Proj. No.: H0562C  
File Loc.: Westminster

California Regional Water Quality Control Board  
Central Coast Region  
895 Aero Vista Drive, Suite 101  
San Luis Obispo, CA 93401

**RE: REVIEW OF OLIN STATEMENT REGARDING NORTHEAST FLOW**

Attachment 2.1: Excerpt from Mactec, December 20, 2005 RWQCB Meeting Presentation depicting contouring of USGS water level data from 1916.

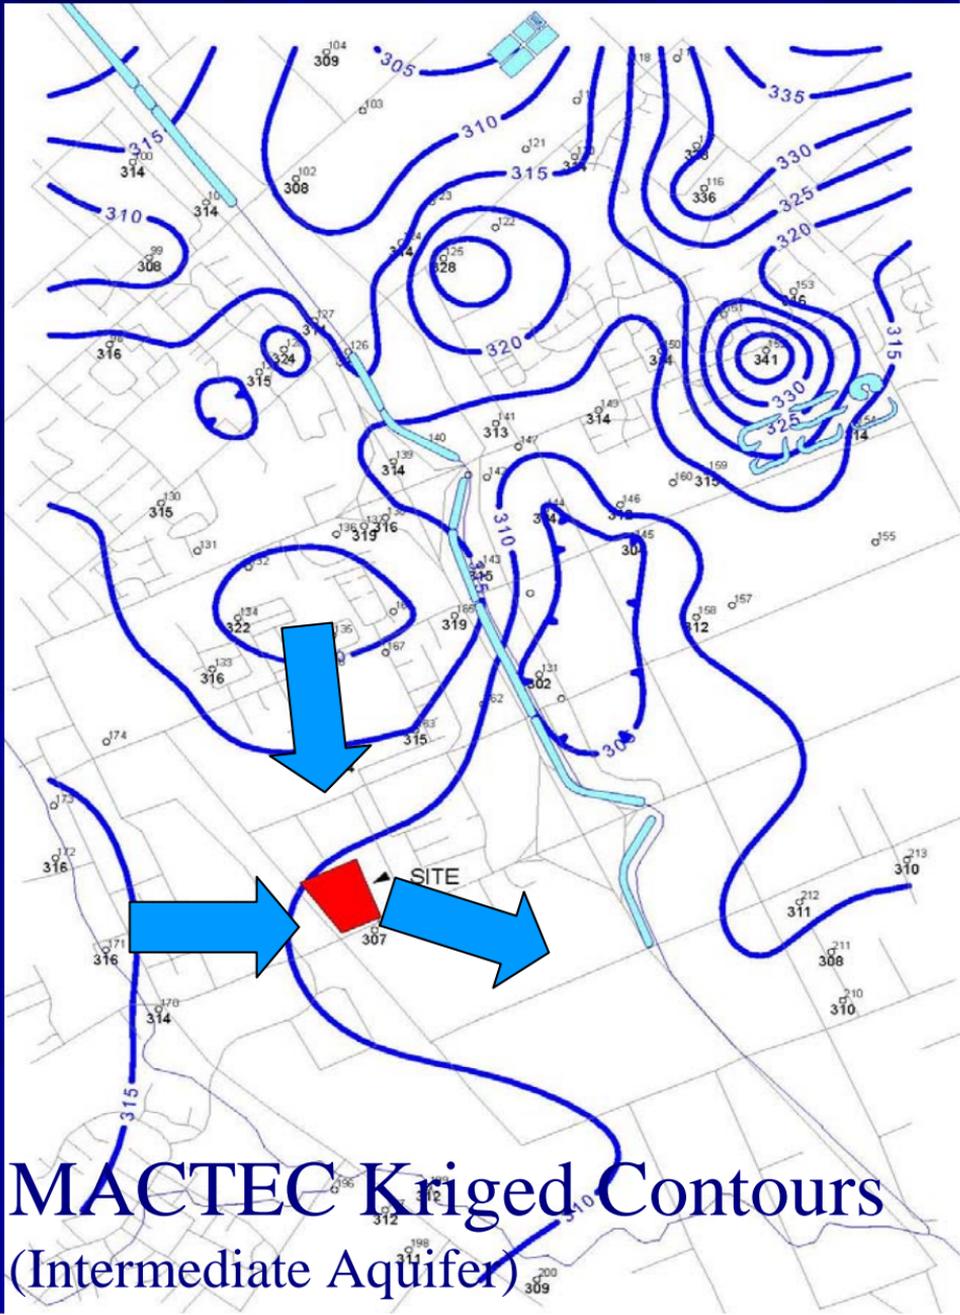
- a. Interpretation of the 1916 United States Geological Survey Data by Olin's consultant showing eastward and northward flow to the east of the Olin Site (Attachment 2.1);

Attachment 2.2: Groundwater contour figures from Mactec, October 24, 2004 Groundwater Flow Assessment White Paper.

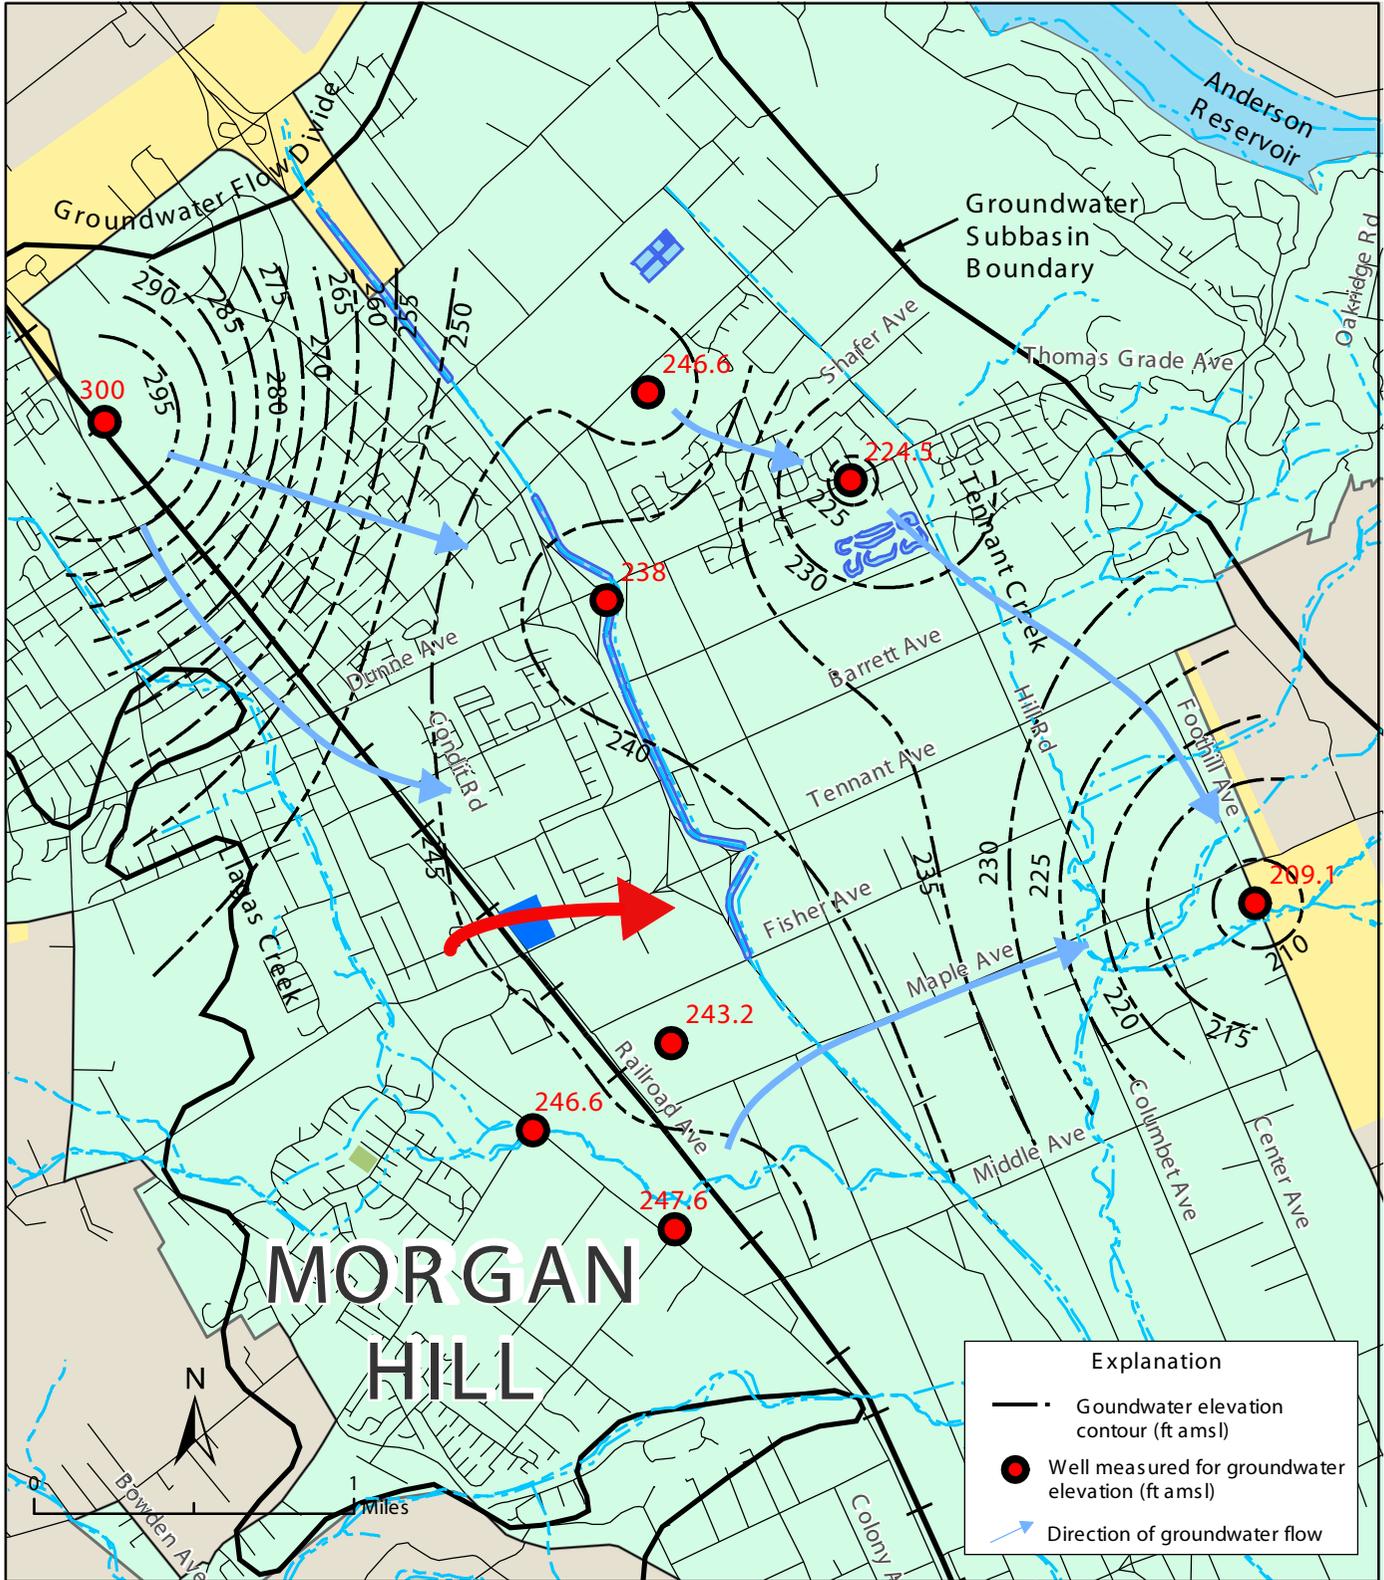
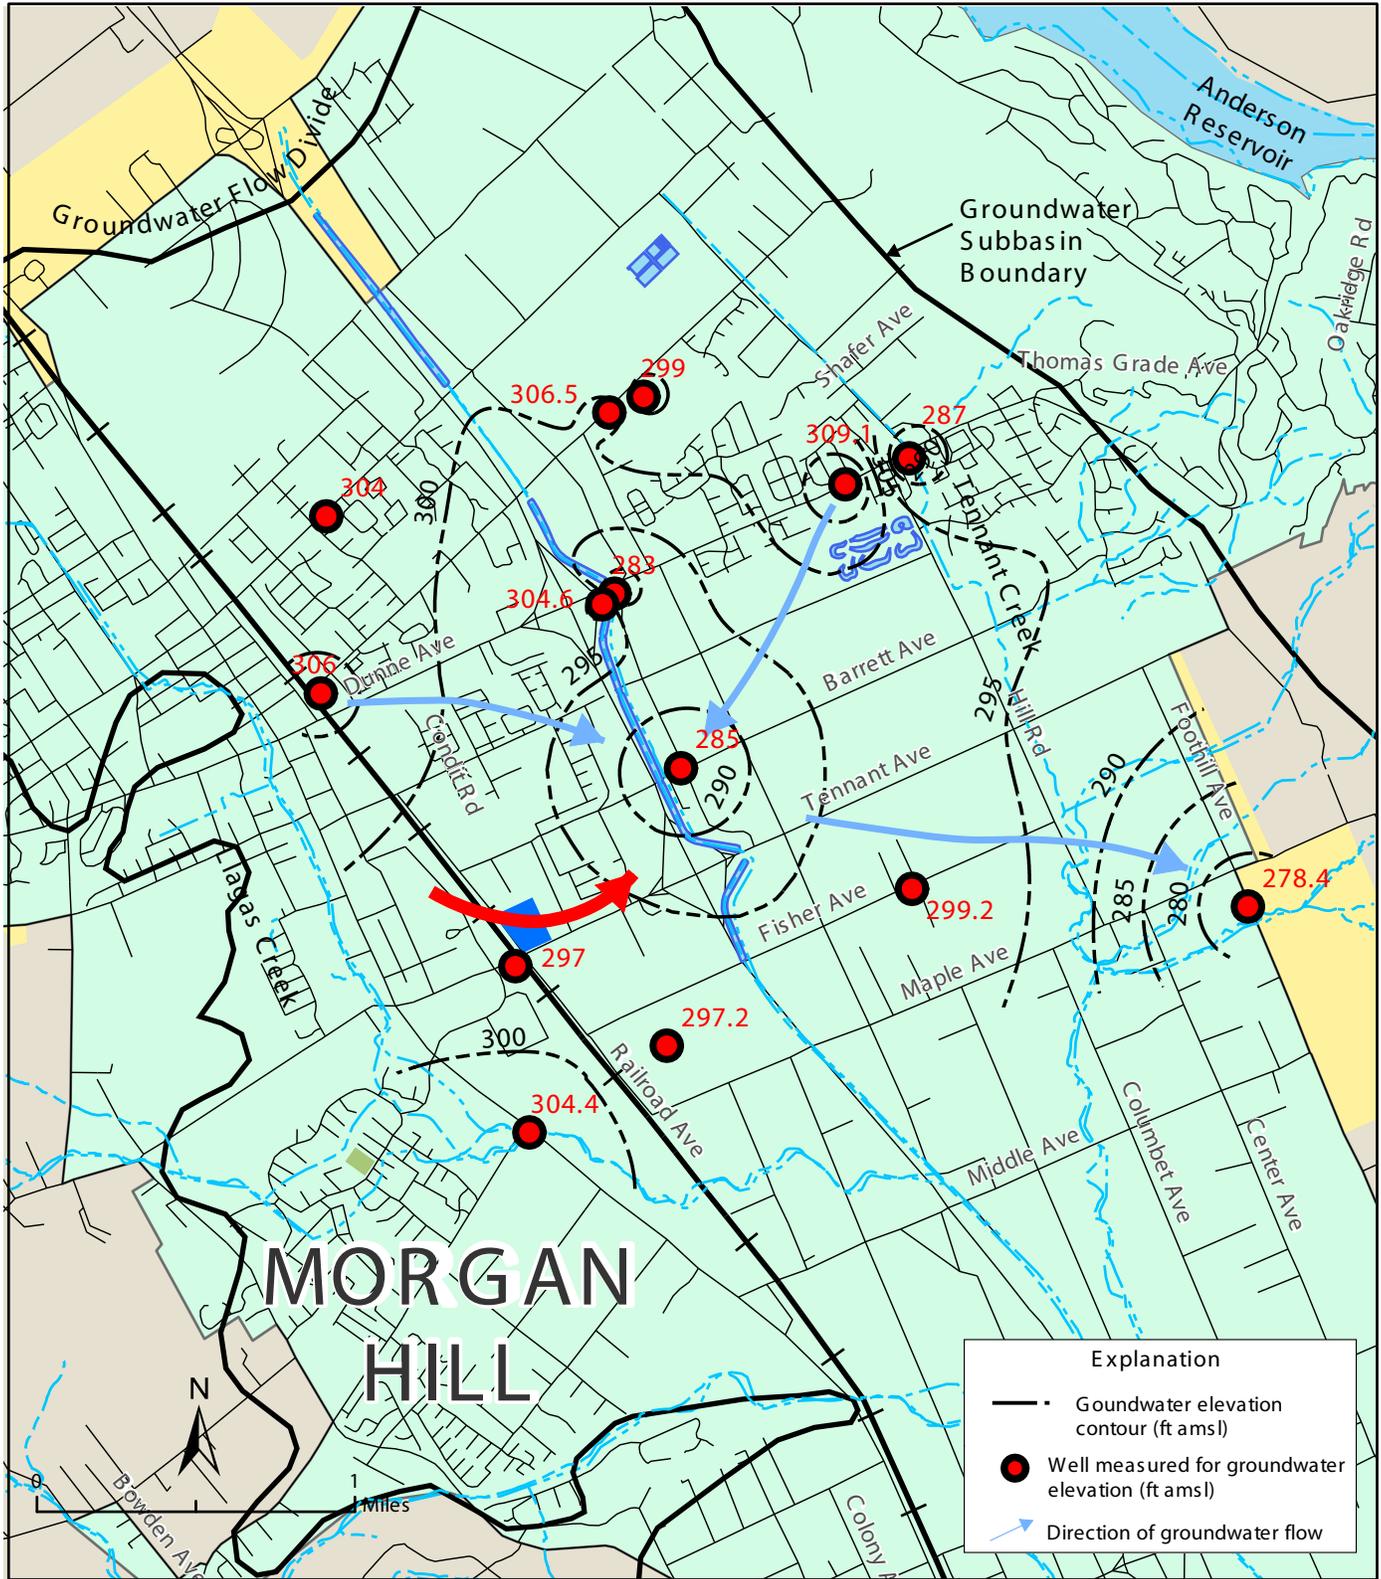
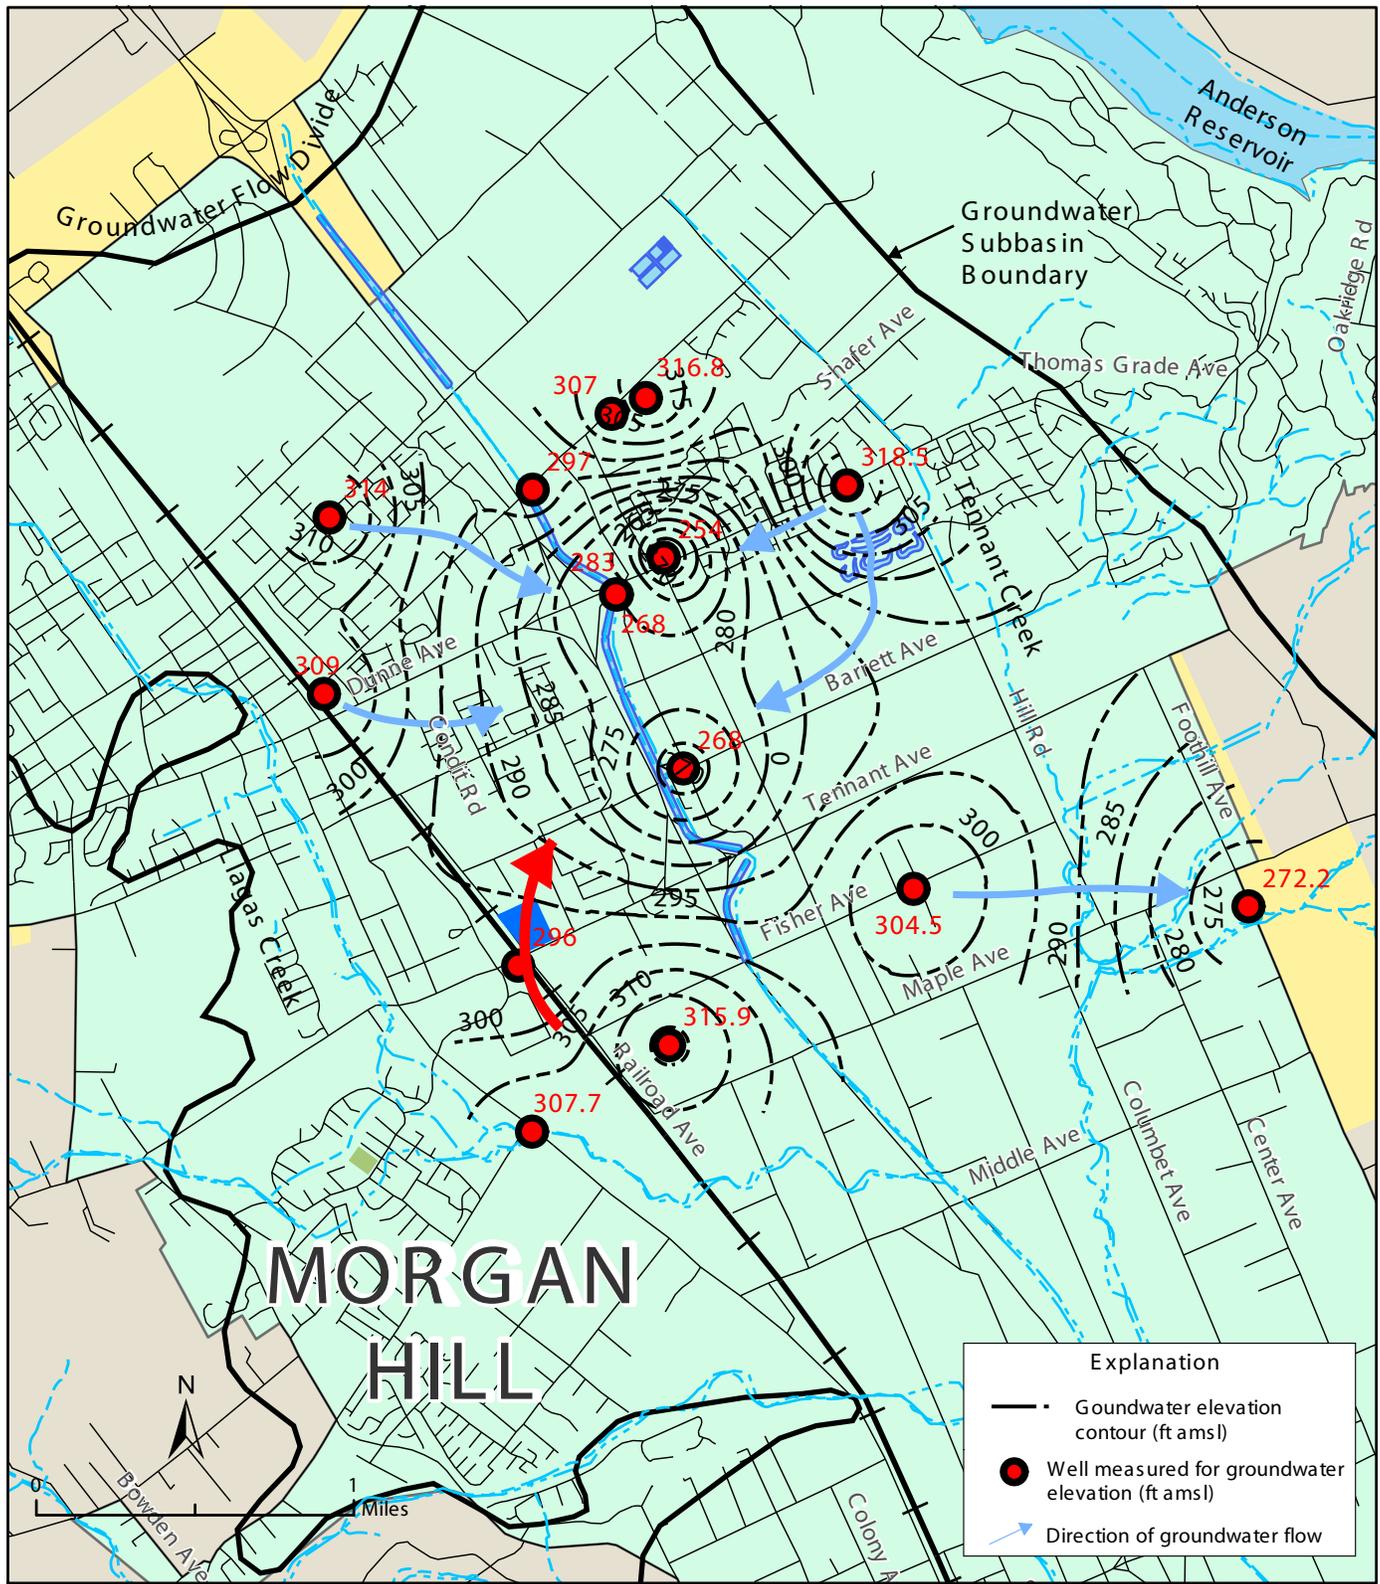
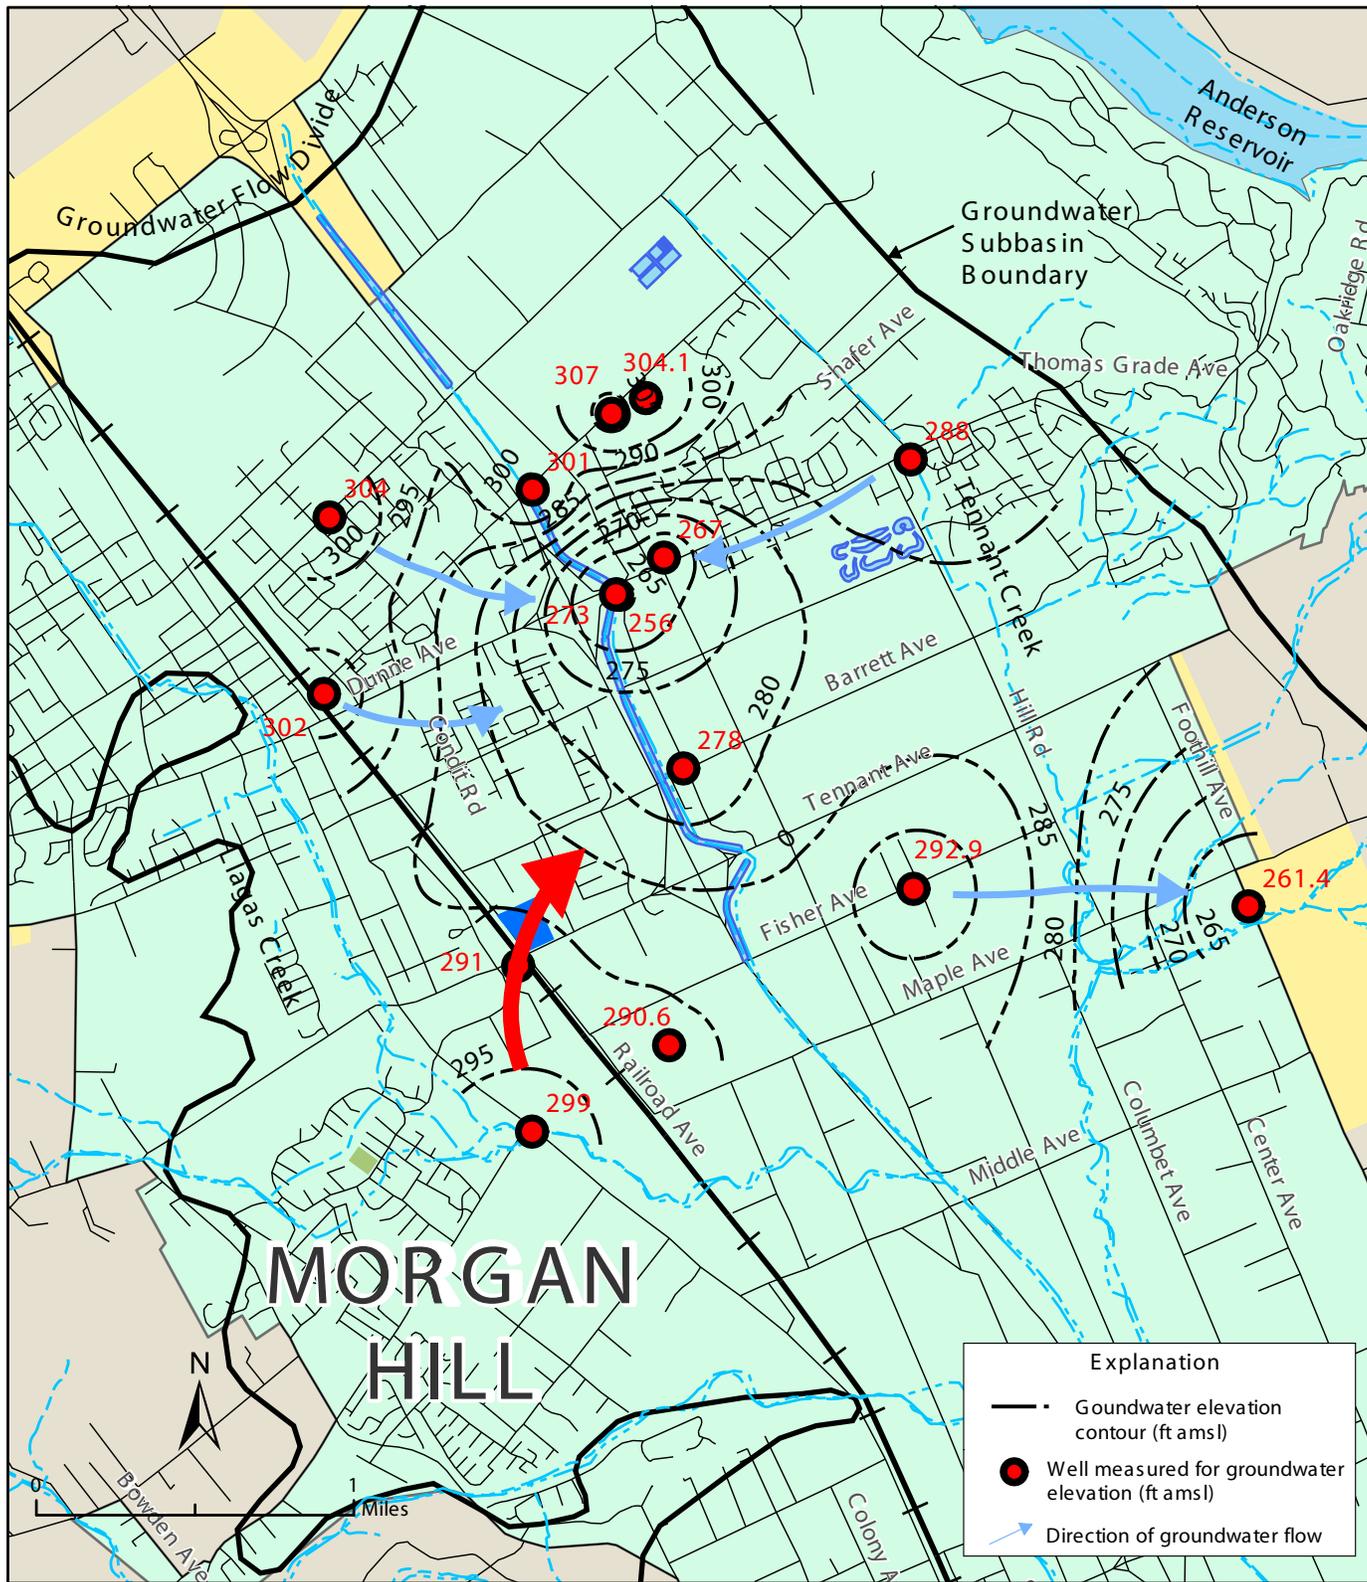
- b. Several occurrences of northward or northeasterly flow interpreted by Olin's consultants from historical information in the last decade (Attachment 2.2);
